AMENDMENT REPORT

Kelso Crescent Multi-Level Warehouse, Moorebank

SSD-58978472

17 October 2025

Figure 5: Ground Level Comparison (Source: Nettleton Tribe 2024, PACE Architects 2025)

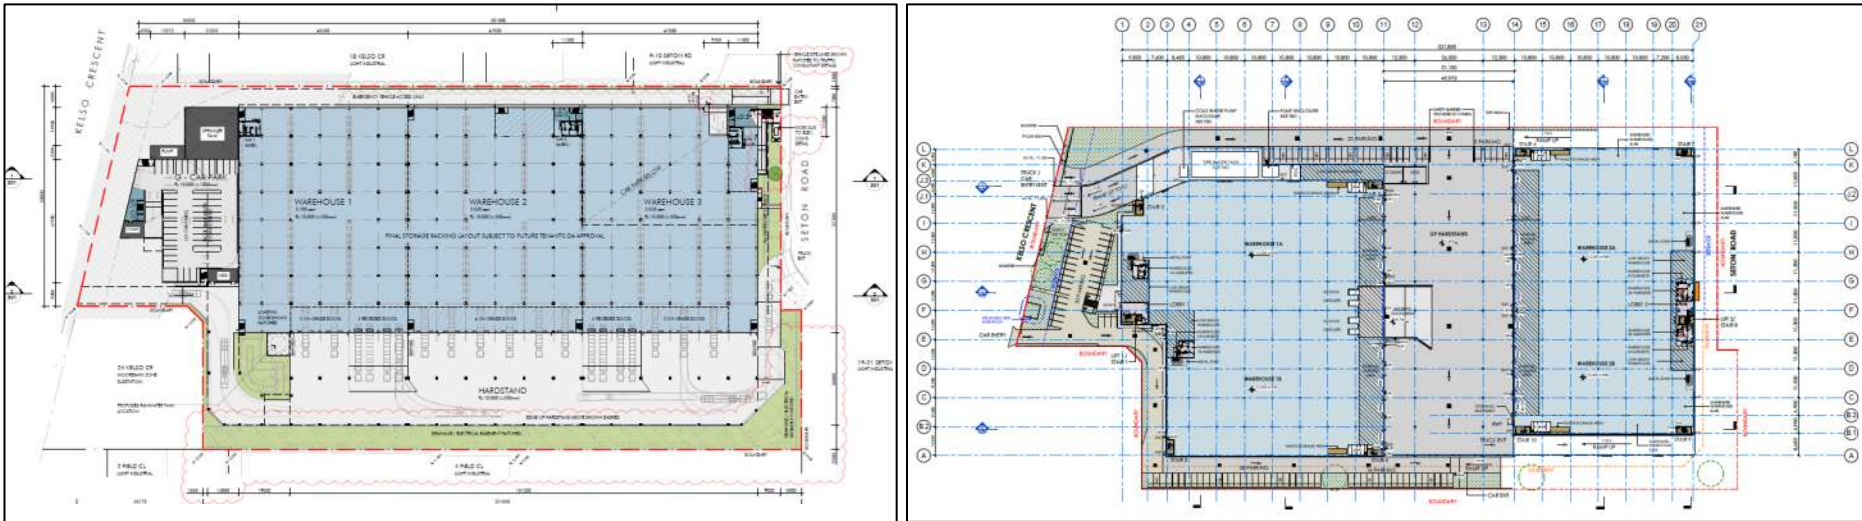
The revised proposal provides two buildings with a central hardstand, amended from the previous proposal for one warehouse building with basement parking. This results in a reduced GFA and improved built form outcome. A comparison of the changes is provided below.

Figure 12: Car Park Access and Egress – Ground Floor (Source: PACE Architects, 2025)

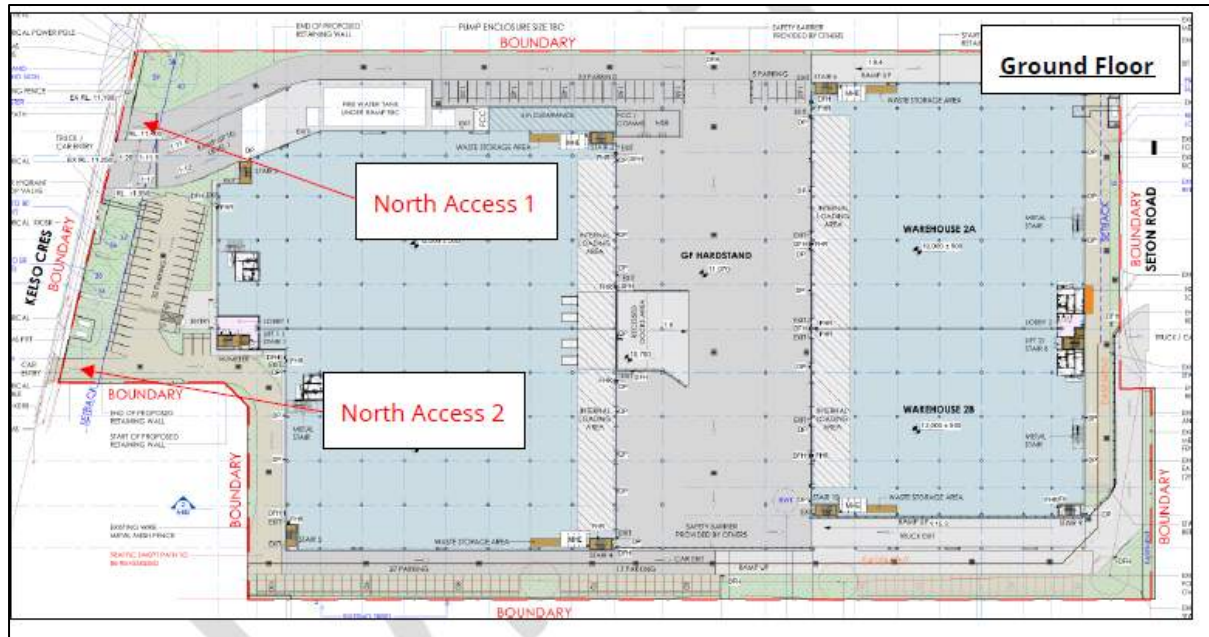
All light vehicles will access the car park via the 2 northern driveways at Kelso Crescent and 1 southern driveway at Seton Road. All drivers will exit via the 2 southern egress points - Refer to **Figure 12** below.

Figure 16: Retention of Trees (Source: Geoscapes. 2025)

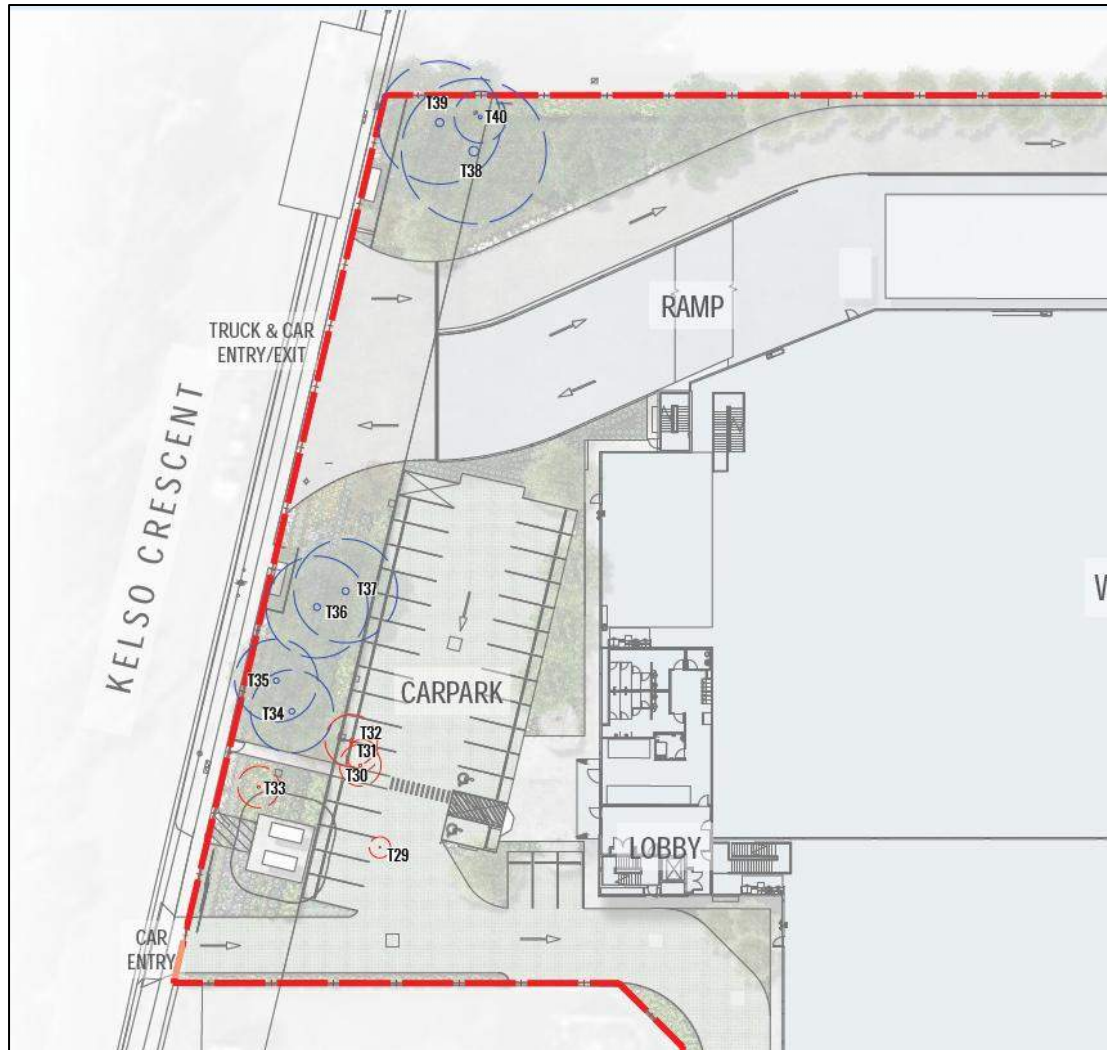
Council raised concern with the original proposal intention to remove a significant tree at the entrance to the site (T36). This tree, and T37, will be retained with the amended proposal – refer to **Figure 16** below. This is an improvement to the previous design and a key benefit of the amended design.
